Access Compliance Report

Public Rights-of-Way

| Intersection ID: 53421 | Main Street: ARDREY_KELL_RD | Cross Street: N/A | Location: NW |
| ADA ID: 22DD3E286CC5 | Ramp Type: Perp | Initial Pass/Fail: Fail | Overall Compliance: No |

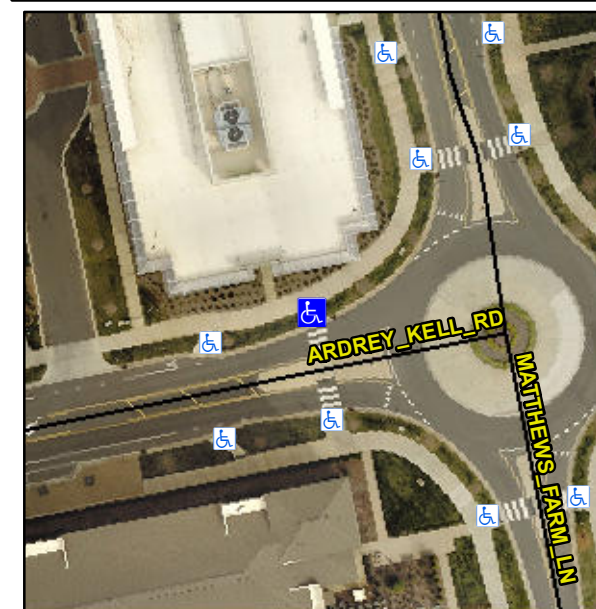
Not Found, R304.2.2

| Compliance | Description | Data | Compliance | Description | Data |
|------------|-----------------------|-------|------------|-----------------------------|------|
| N/A | Ramp Length (in) | 96.0 | No | Ramp Slope (%) | 8.6 |

Remove & Replace Entire Ramp.
